STATE OF NORTH CAROLINA
DEPARTMENT OF TRANSPORTATION

October 18, 2012

Subject: **Application for Individual Section 404 Permit and Section 401 Water Quality Certification** for George Liles Parkway – from South of SR 1304 (Roberta Road) to SR 1341 (Weddington Road), Cabarrus County; Federal ID No. STP-00S(46), NCDOT Division 10; TIP No. R-2246B.
Debit \$570.00 from WBS Element No. 34408.1.1

Permit Drawing
Sheet **5** of **27**

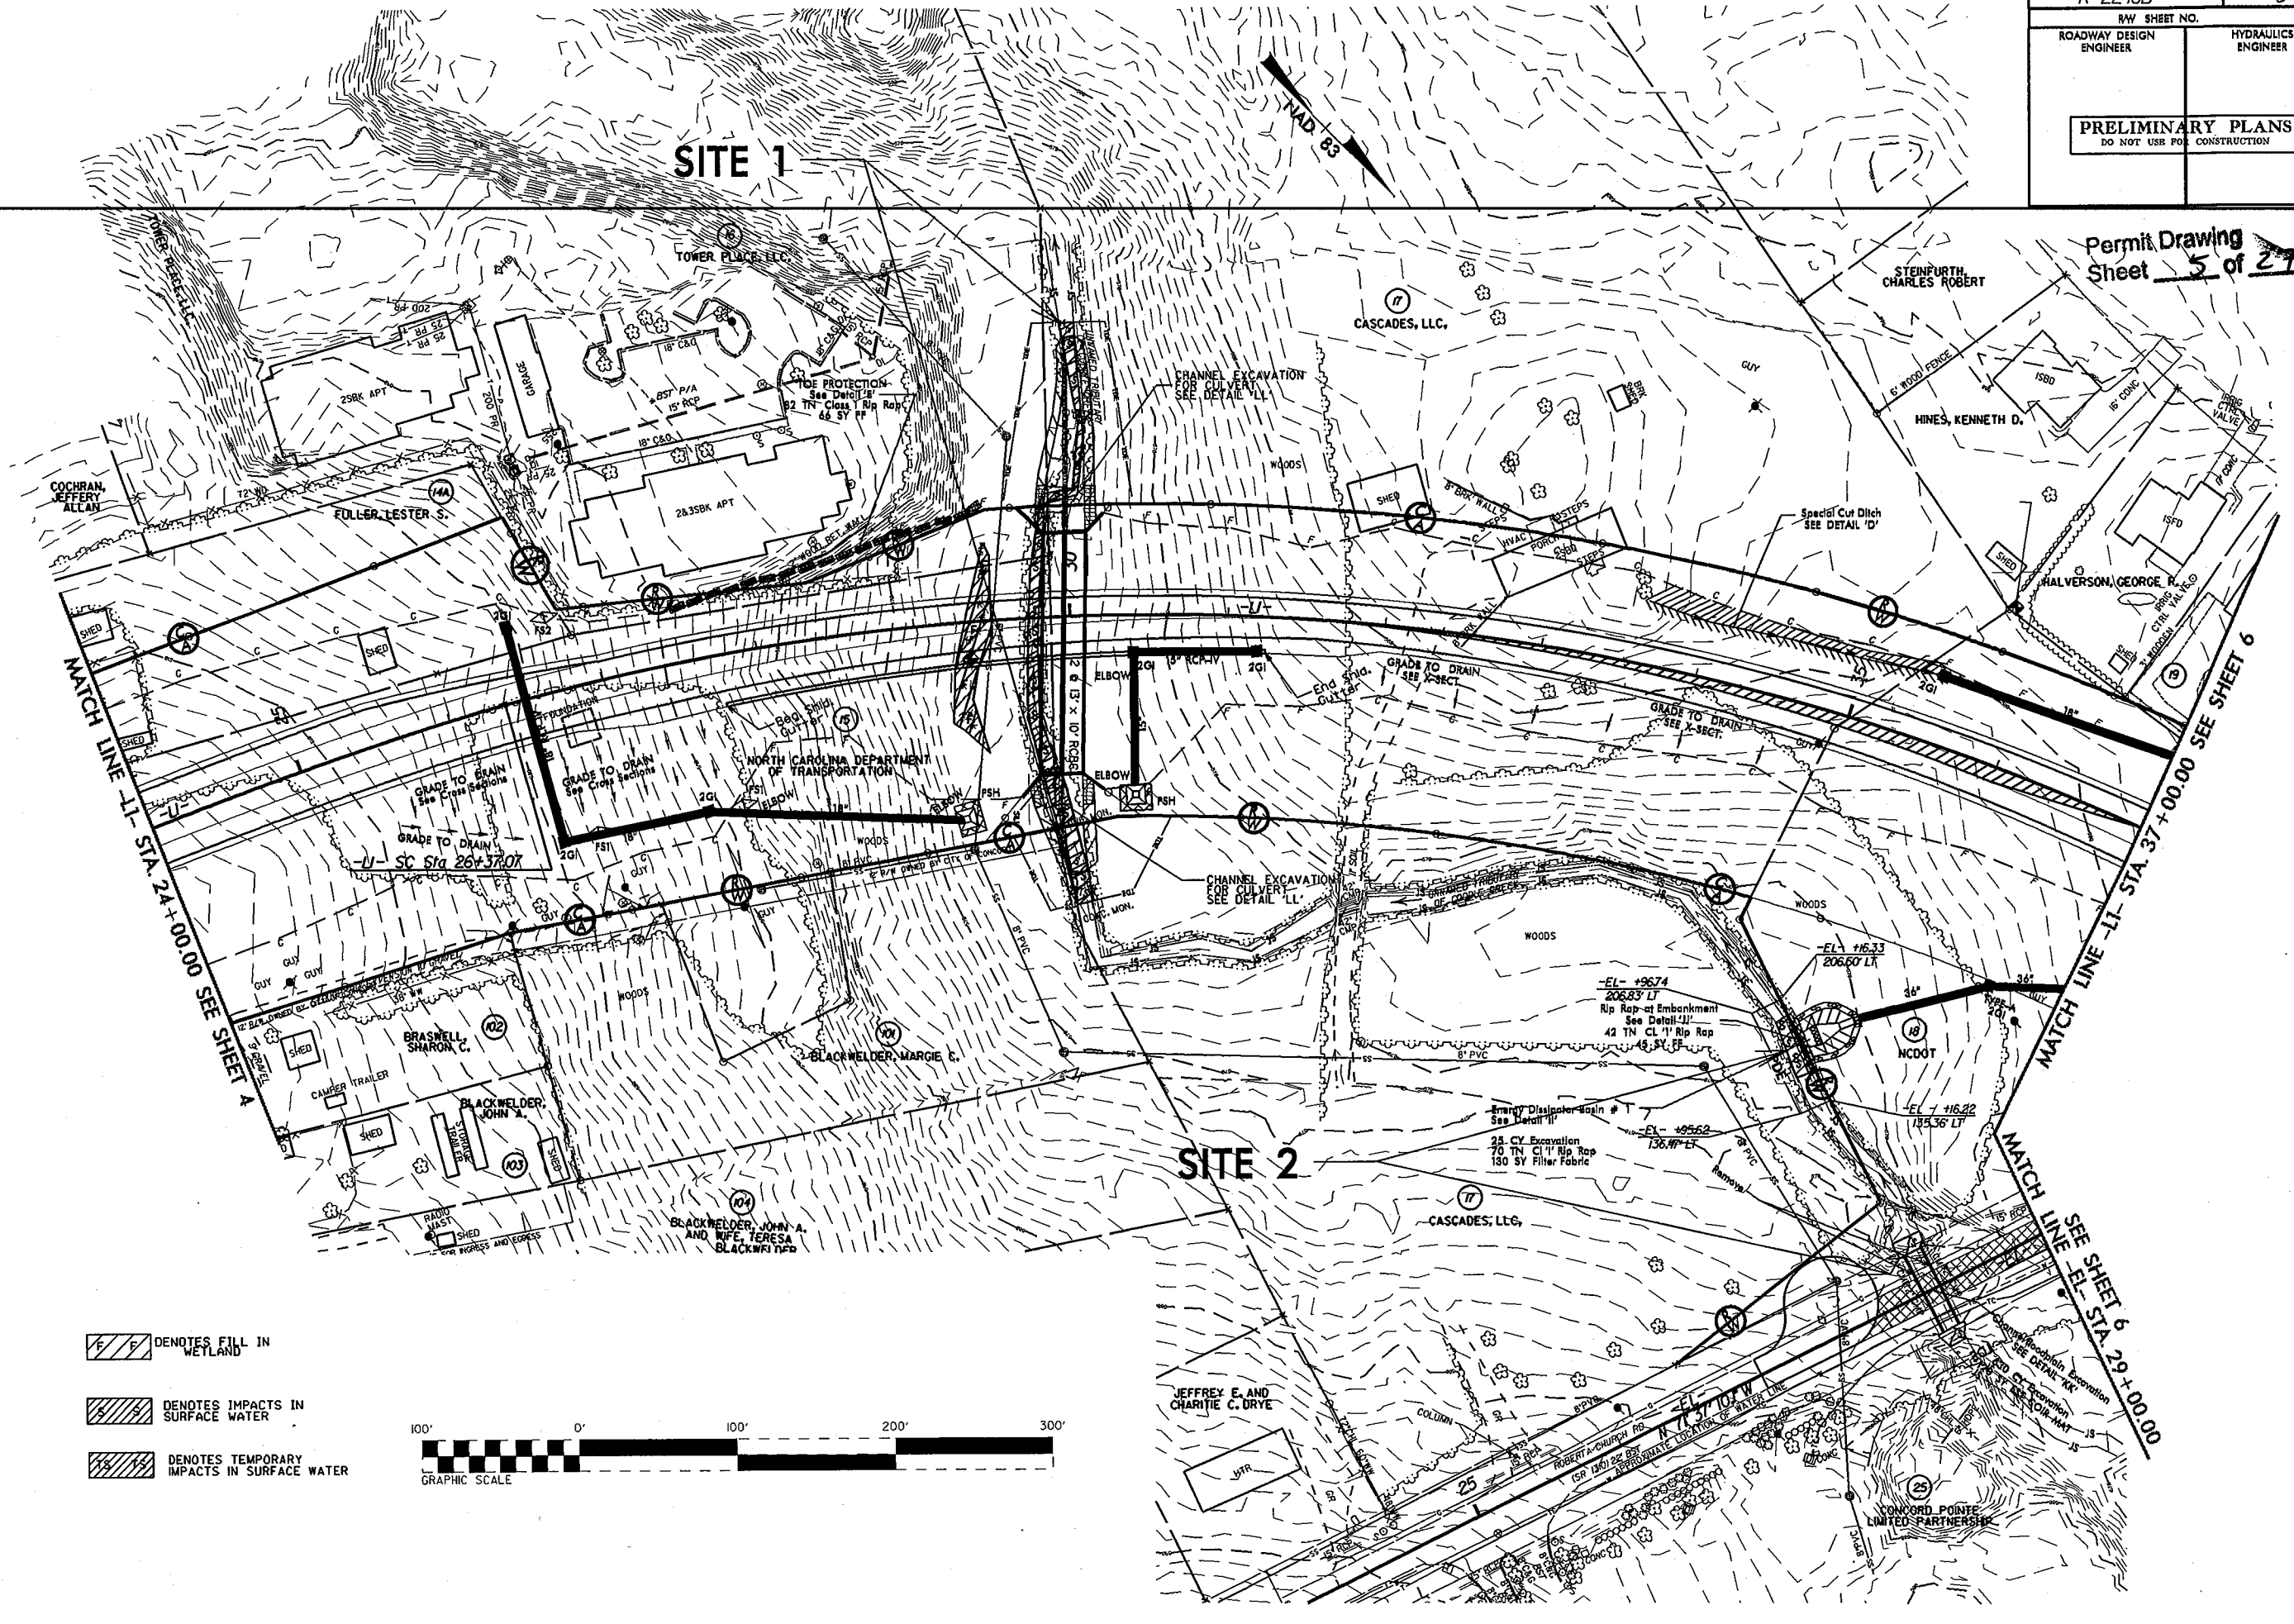
I have reviewed the drawings and other information provided. At Site #2, plan sheet 5; I ask that you try to get the energy dissipater pad aligned at more of an angle to the stream. Currently, the proposed outlet from the pad is aimed perpendicular to the stream.

Permit Drawing
Sheet 21 of 27

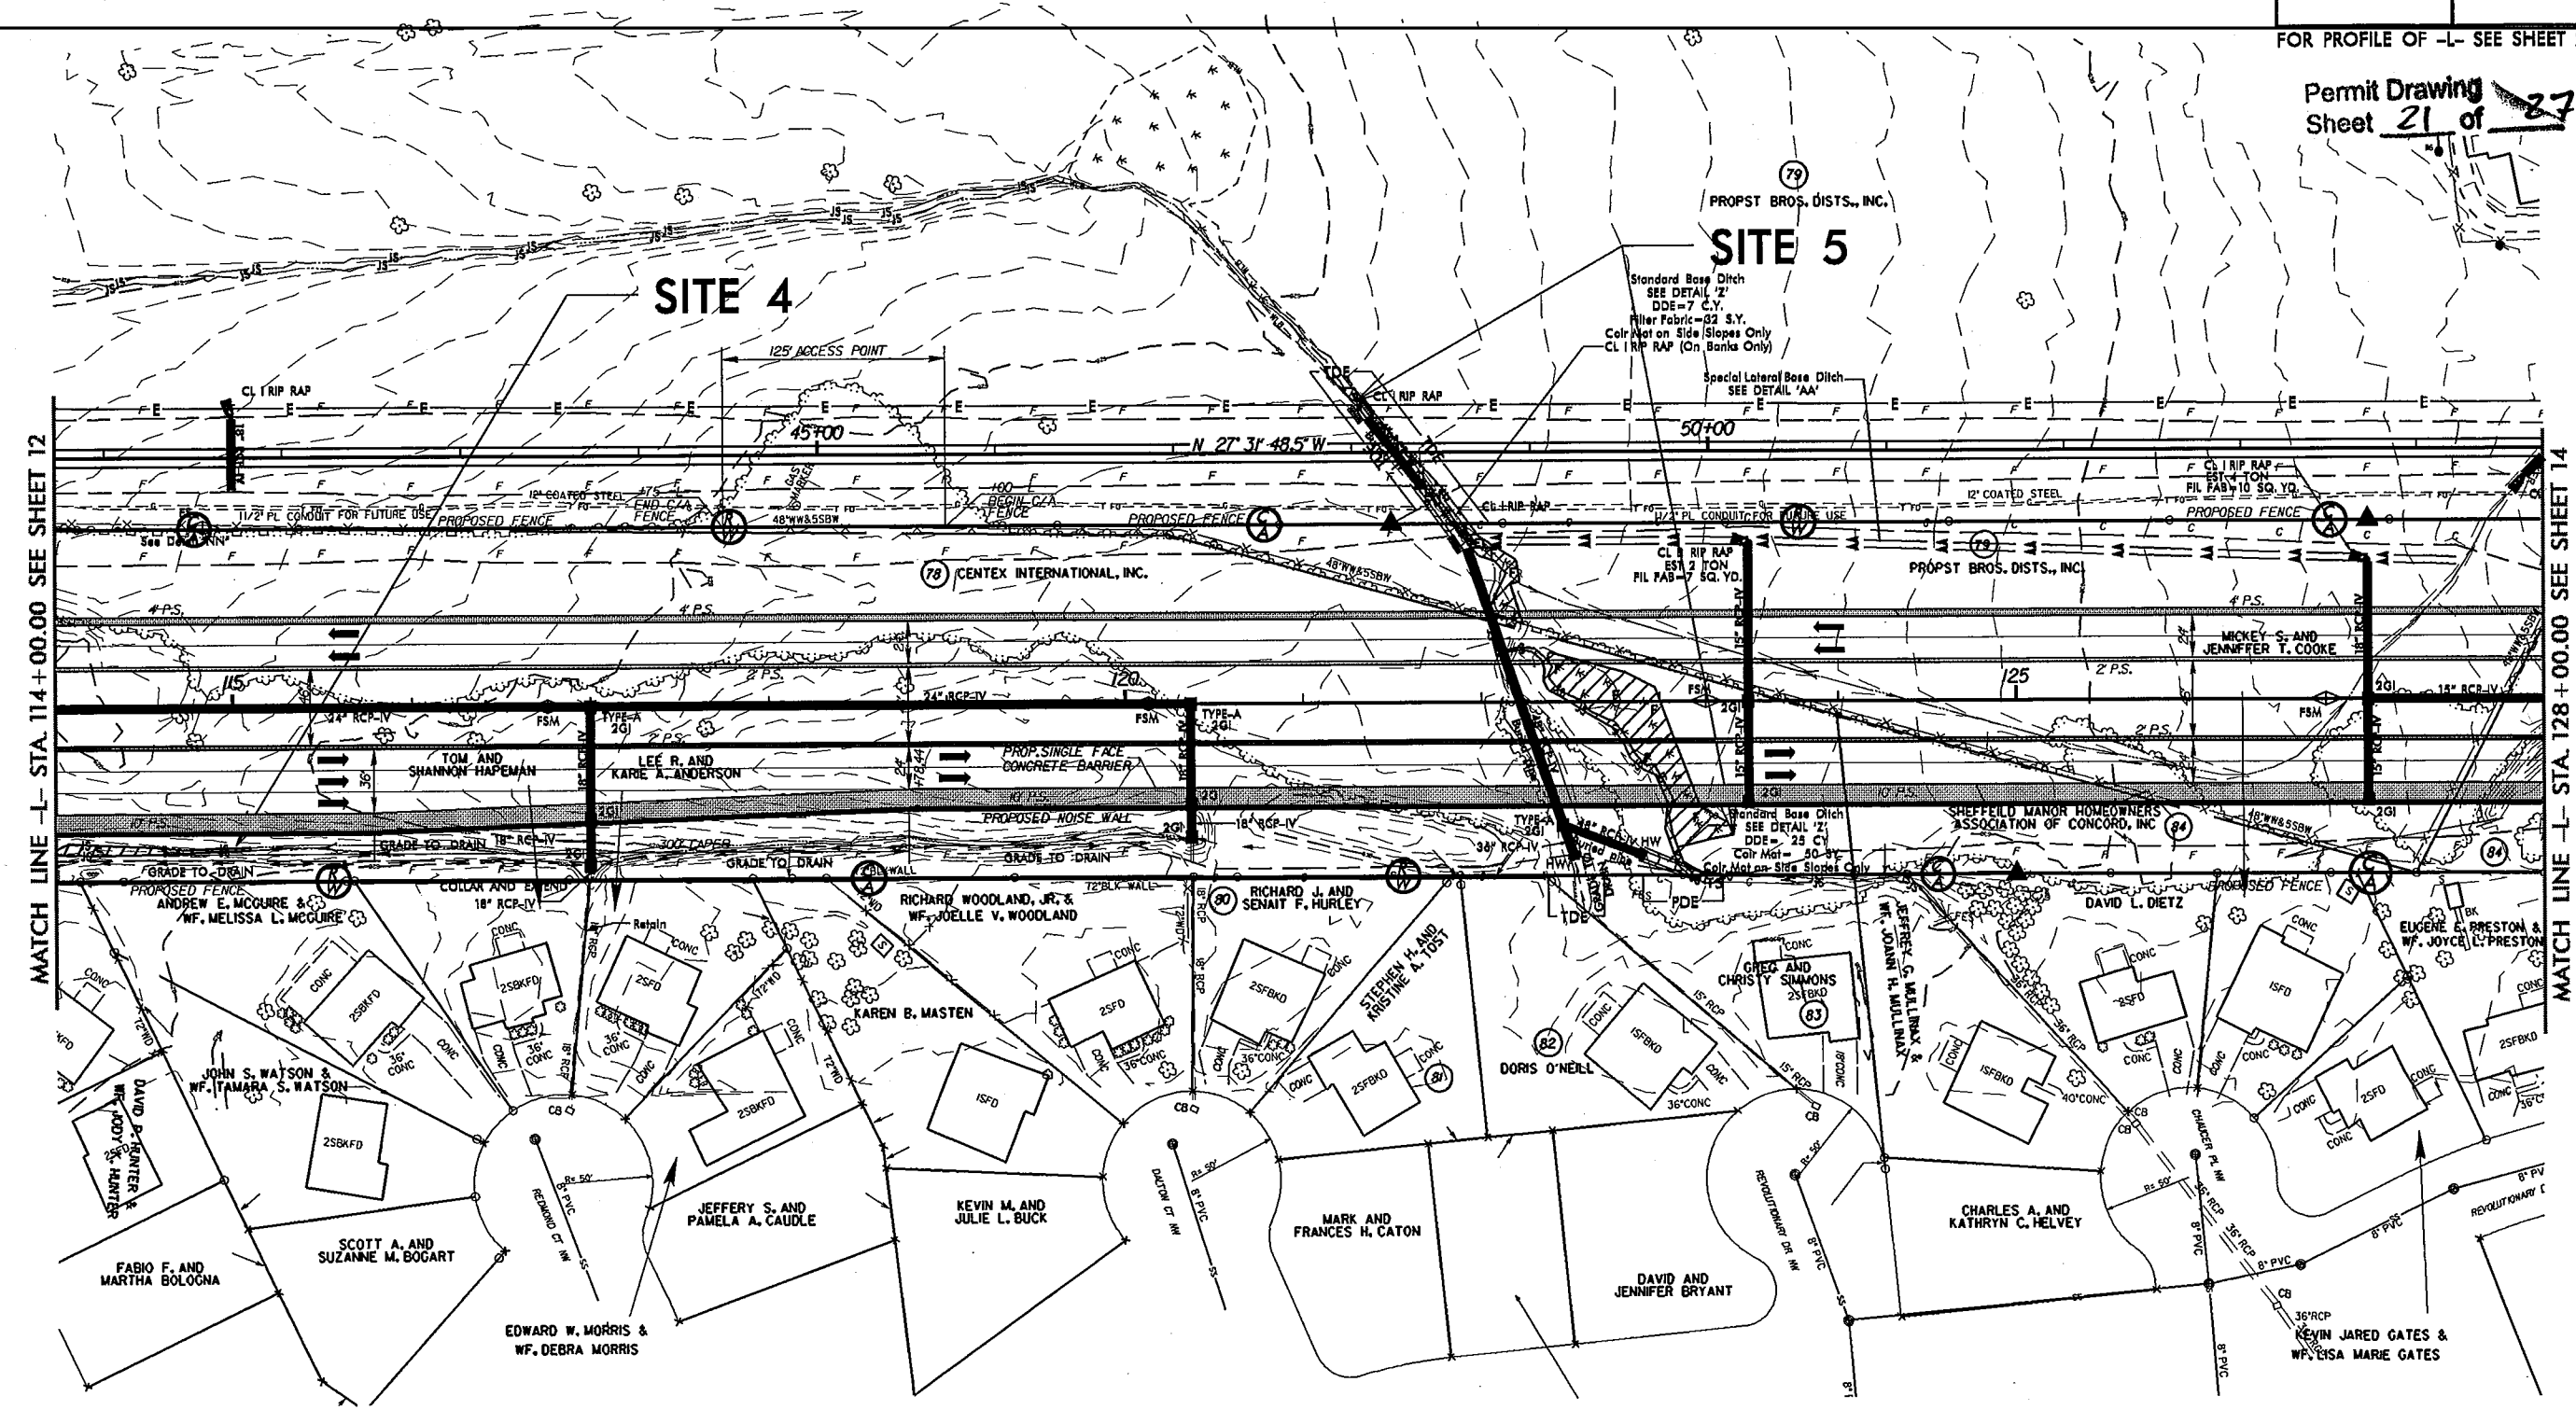
- Detail Z shows coir fiber matting in the stream. The plans indicate coir fiber on the slopes only (along with Class I riprap). Please clarify.

Detail 'Z' was revised to show coir fiber matting on the side slopes and not in the stream bed. The Class I rip rap shown is for pipe outlet protection only. The rip rap will only be placed on the side slopes.

Standard Base Ditch
SEE DETAIL 'Z'
DDE=7 C.Y.
Filter Fabric=32 S.Y.
Coir Mat on Side Slopes Only
CL I RIP RAP (On Banks Only)
